HISTORIC AND DESIGN REVIEW COMMISSION

July 19, 2023

HDRC CASE NO: 2023-258
COMMON NAME: 145 NAVARRO
ADDRESS: 219 VILLITA ST
LEGAL DESCRIPTION: NCB 986 LOT 11 THRU 13 AND E 5.14FT OF 10
ZONING: D, H, RIO-3
CITY COUNCIL DIST.: 1
APPLICANT: Peter Ketter/Sandvick Architects
OWNER: Kunal Mody/145 NAVARRO LLC
TYPE OF WORK: Amendment to previously approved design of rooftop addition; infill of windows
APPLICATION RECEIVED: June 30, 2023
60-DAY REVIEW: August 29, 2023
CASE MANAGER: Edward Hall

SITE PLAN

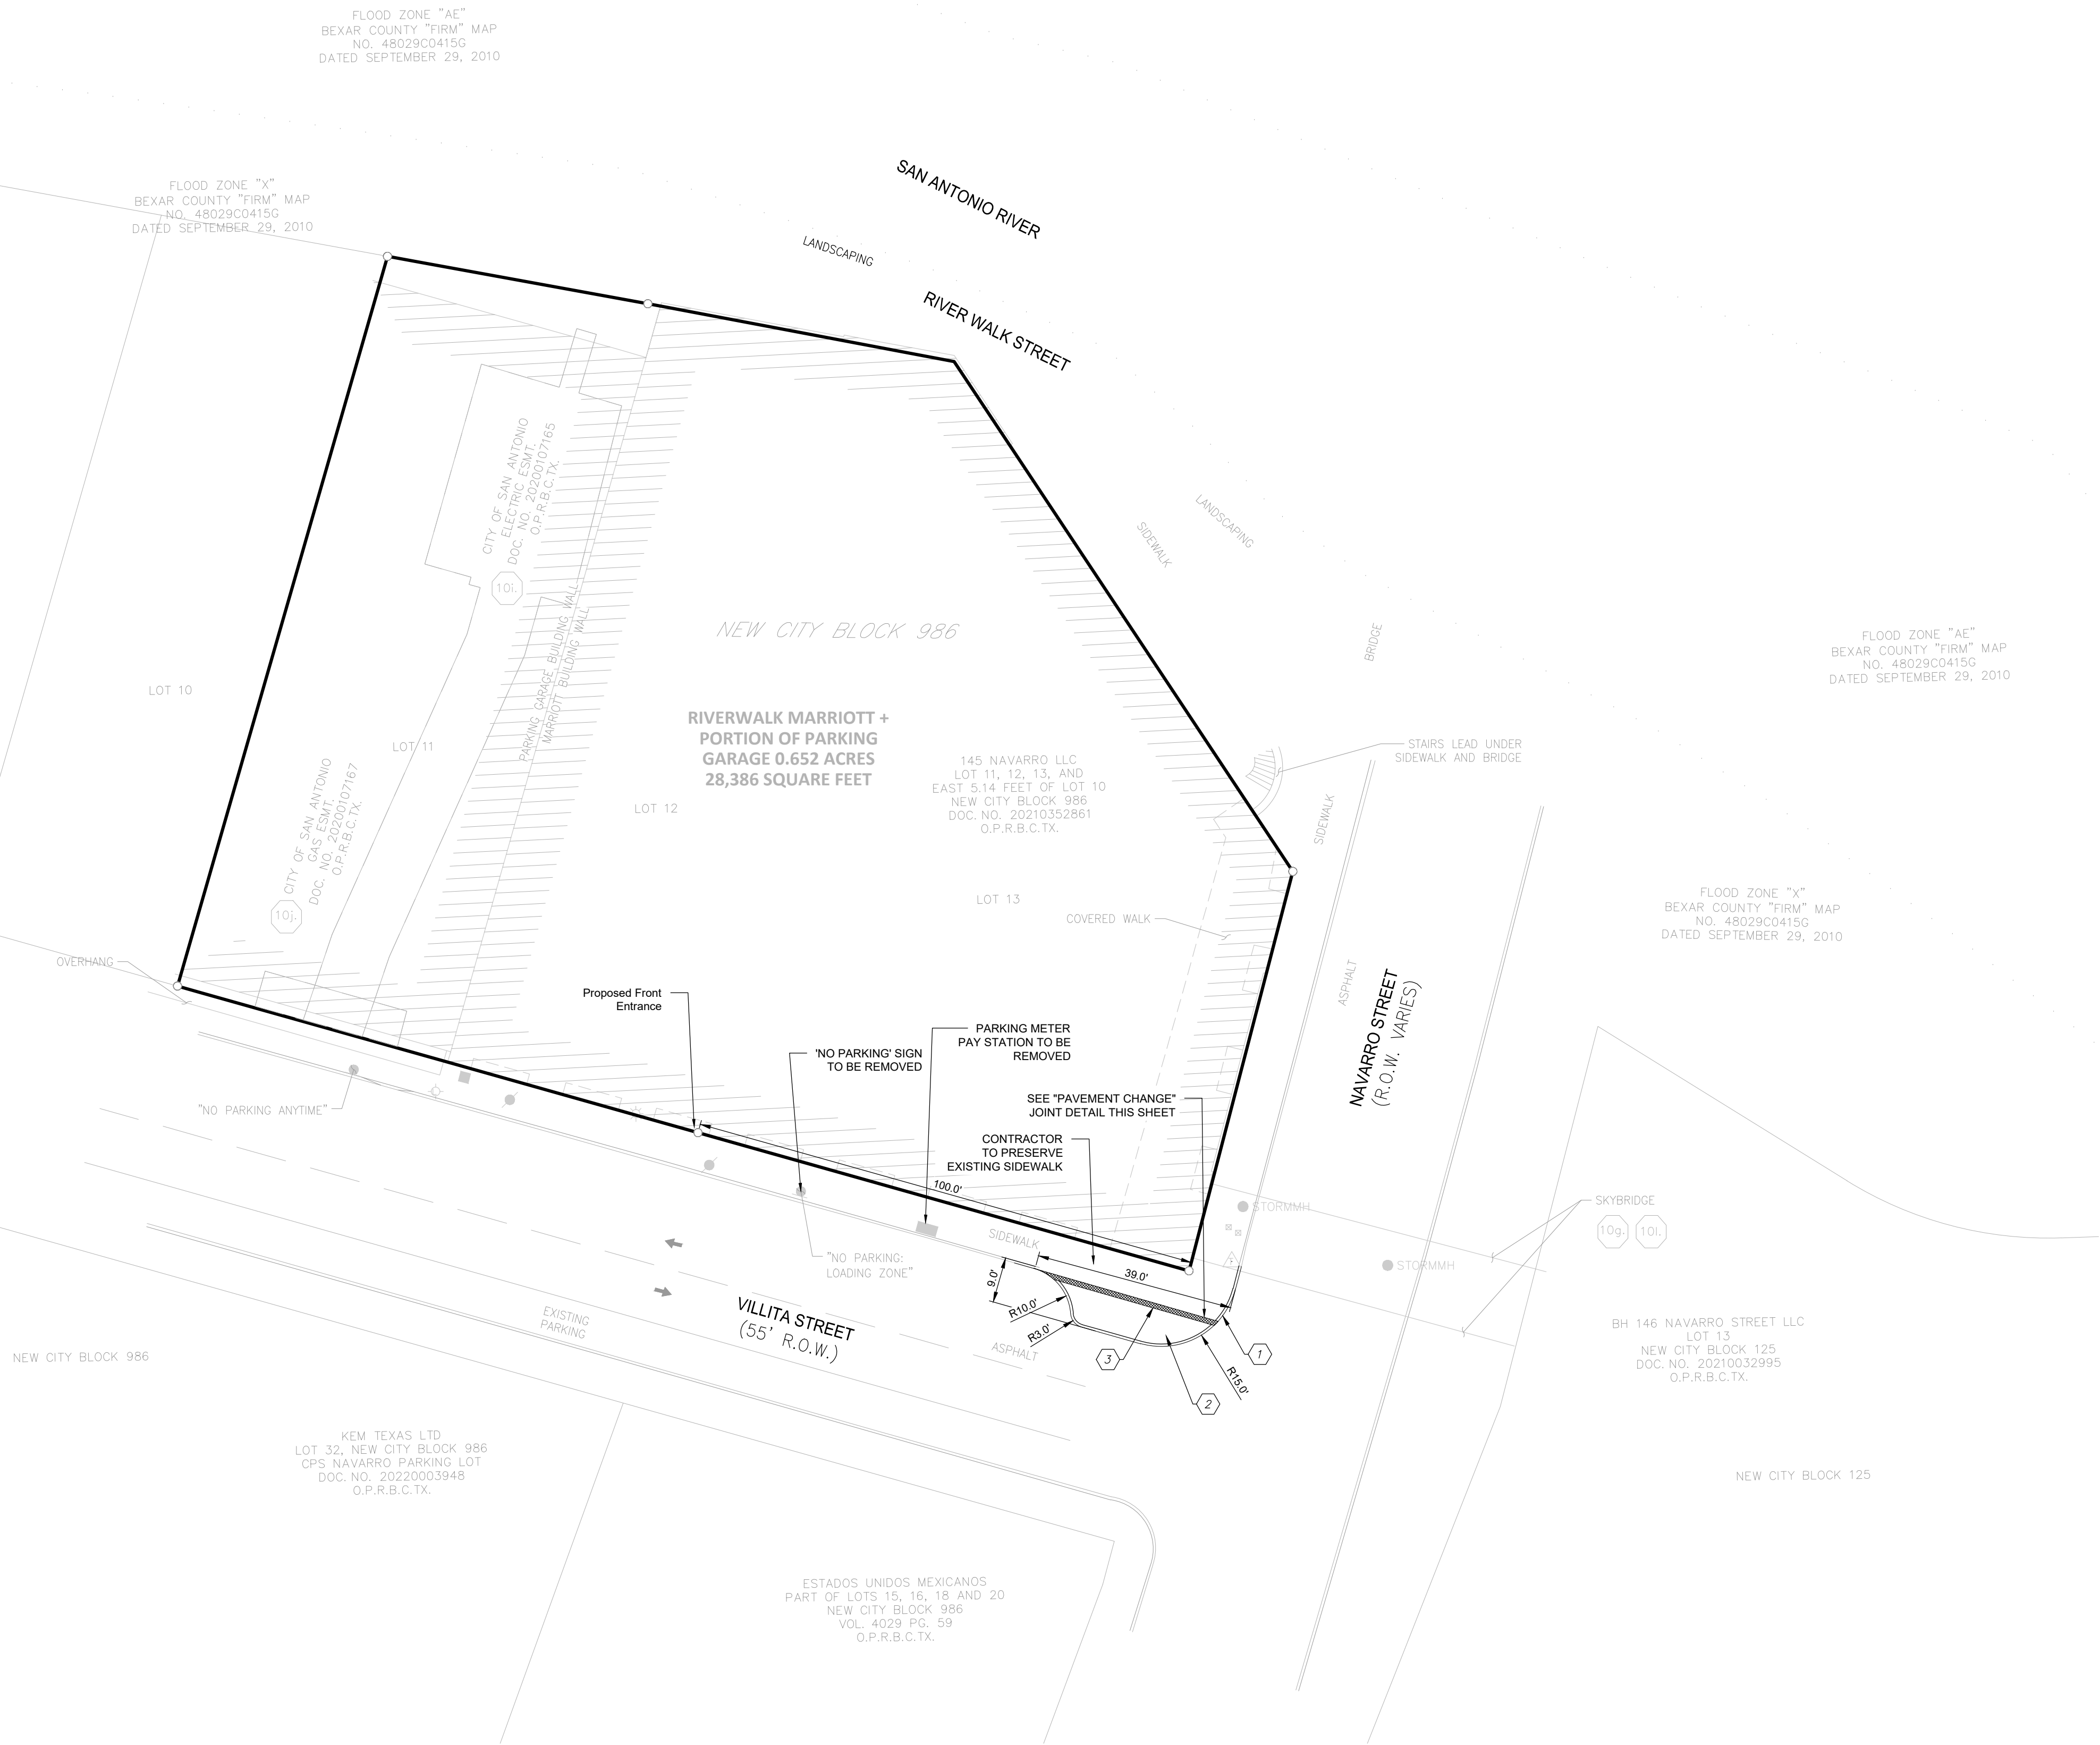
- e. RIGHT OF WAY MODIFICATION – The applicant has proposed to modify the previous concrete parkway proposed to only feature one extension instead of the previously approved two. Staff finds this reduction to be appropriate. The applicant has noted the intent to comply with the previous stipulation of approval, confirming with the Downtown Design Guide’s sidewalk and street planting standards as outlined in Chapter 2, Section A and Chapter 8, Section E. The applicant is responsible for coordinating all right of way work with the Public Works Department.

- 1. Staff recommends approval of item #1, the infill of non-original window openings on the west façade as noted in finding c.
- 2. Staff recommends approval of item #2, modifications to the design and height of rooftop additions based on finding d with the following stipulation:
 - i. That EIFS feature a finish and control joints similar to traditionally applied stucco/plaster.
- 3. Staff recommends approval of item #3, modifications to the proposed right of way parkway based on finding e with the following stipulation:
 - i. That street trees or landscaping beds be installed in the parkway. The applicant is to follow the Downtown Design Guide’s sidewalk and street planting standards as outlined in Chapter 2, Section A and Chapter 8, Section E.

TITLE:
West Elevation

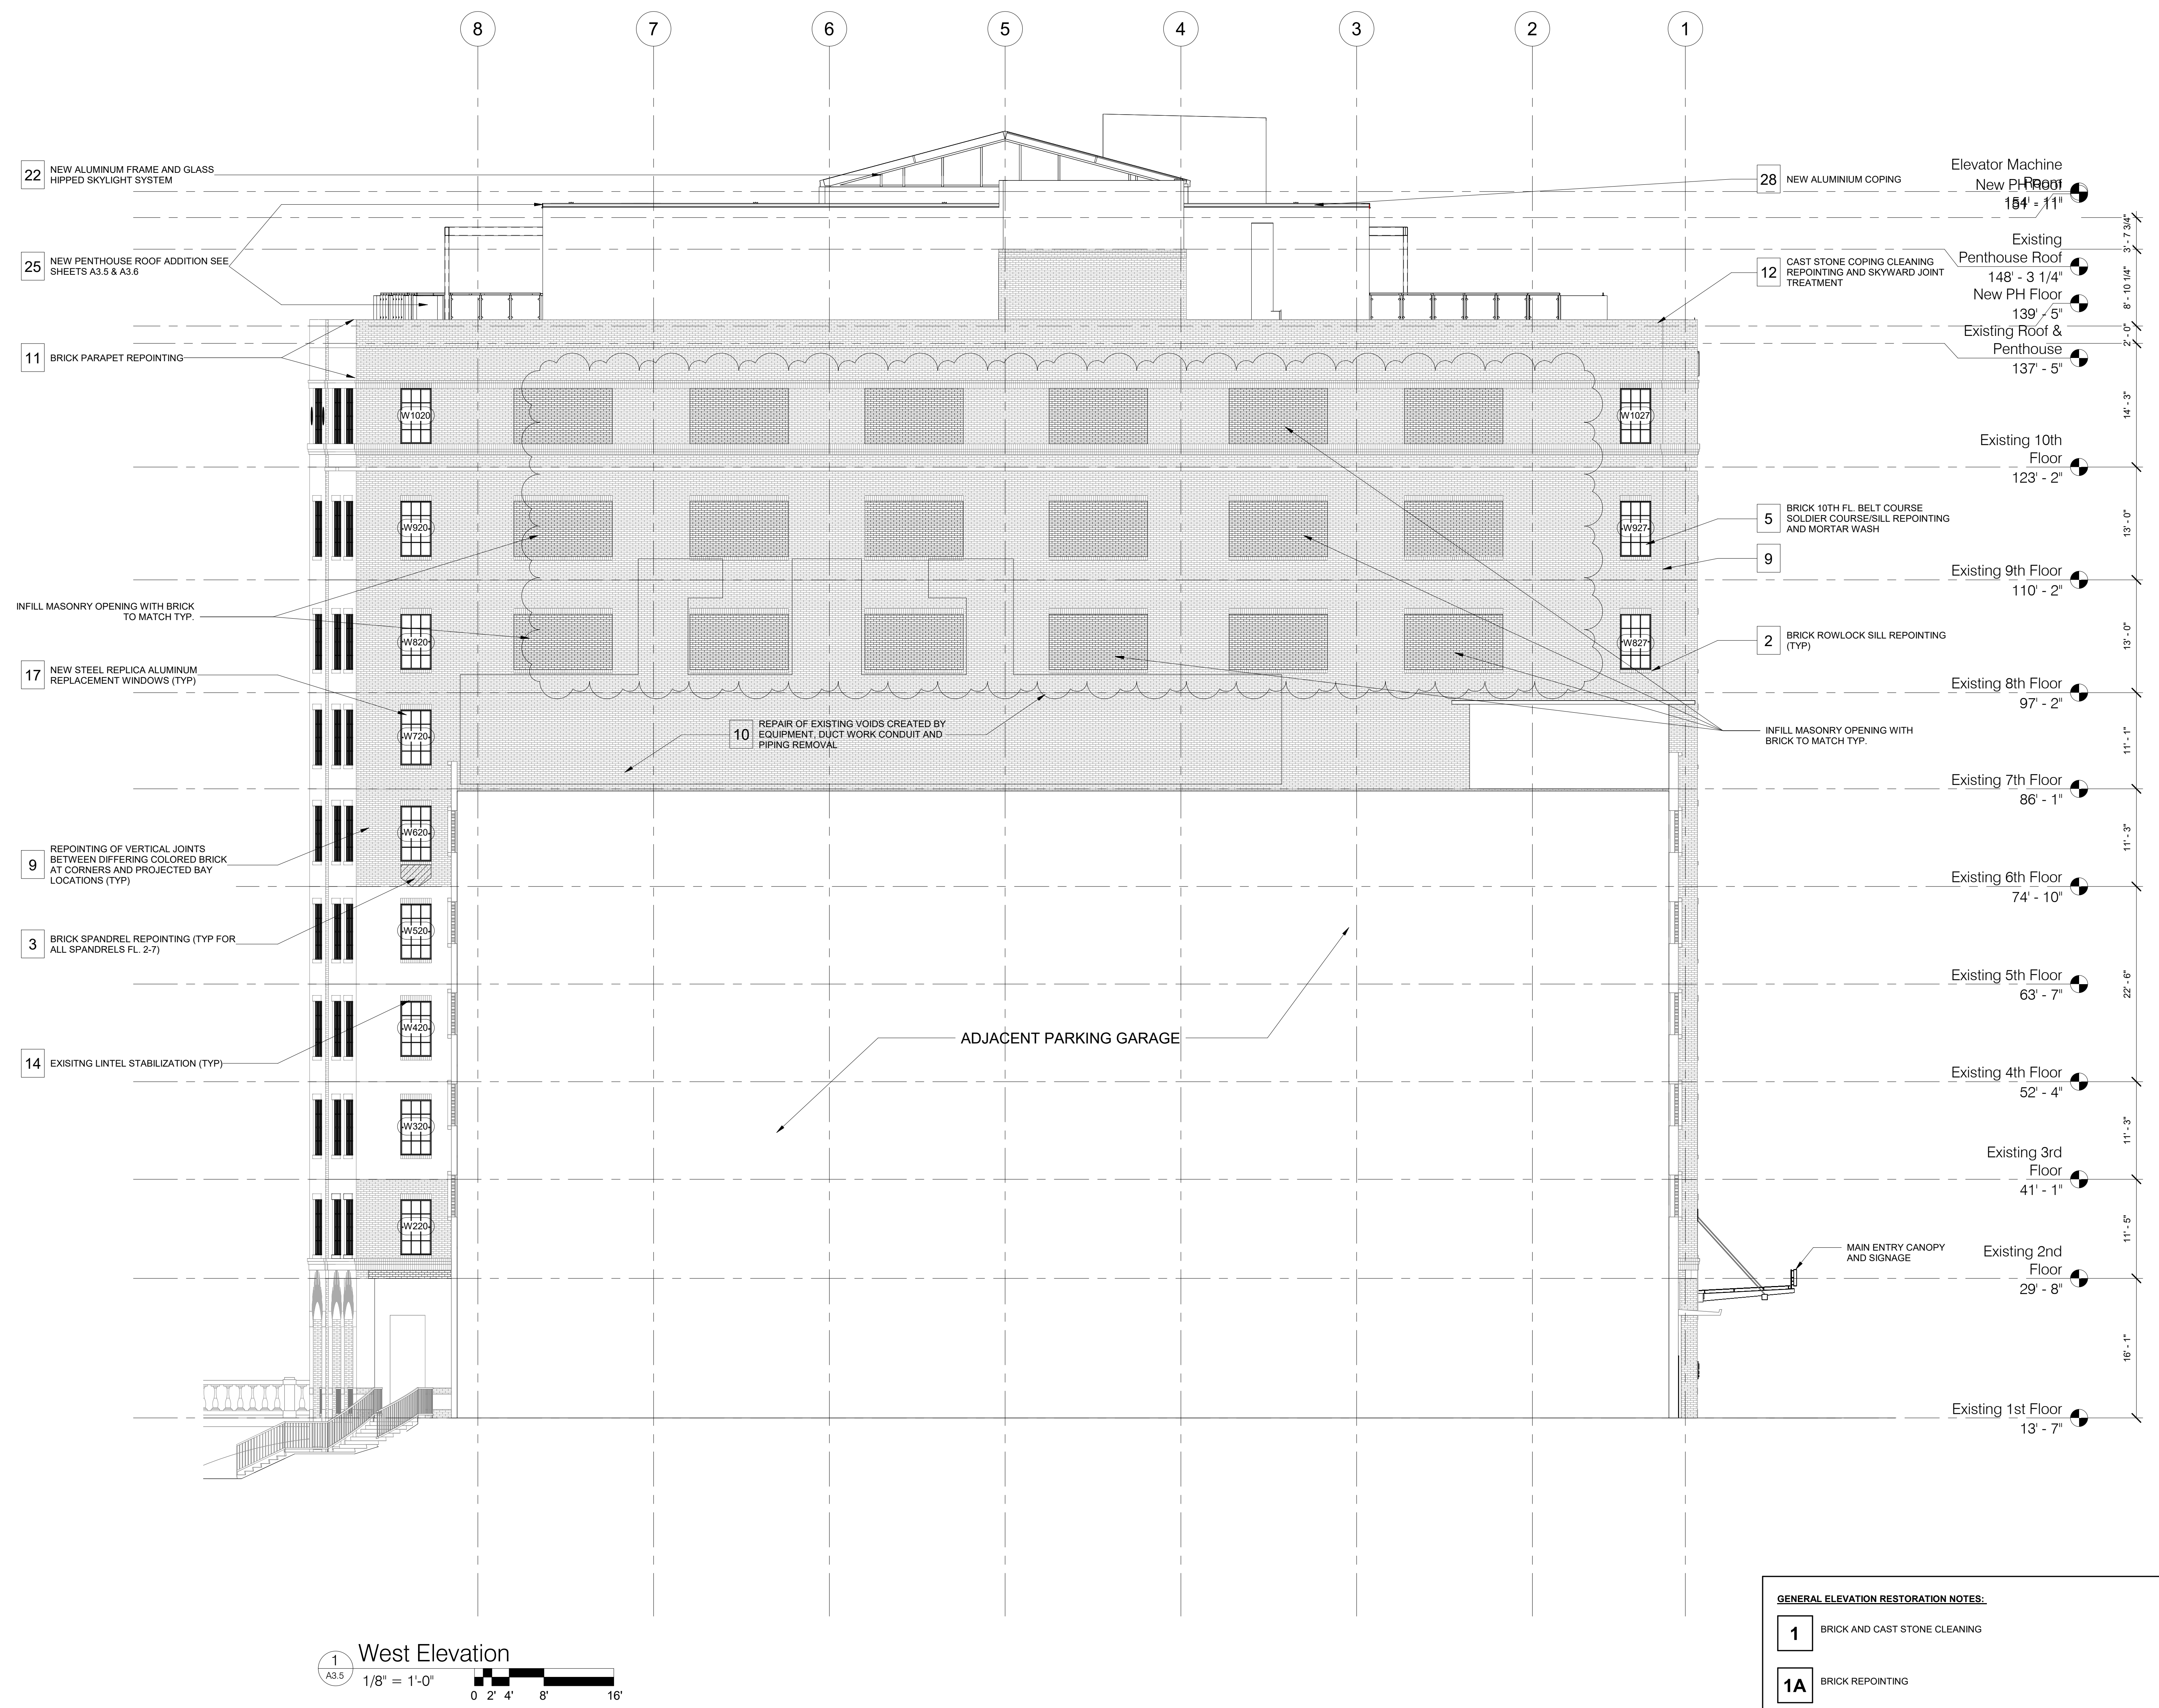
- c. WINDOW ENCLOSURE – The applicant has proposed to enclose eighteen (18) window openings on the west façade with brick. These window openings are from a 1984 addition. The applicant has proposed to infill each window with brick to match the existing brick, with a recess. Given the location of these window openings within an addition, their location above an adjacent parking structure, and the proposed infill method, staff finds the proposed scope of work to be appropriate.
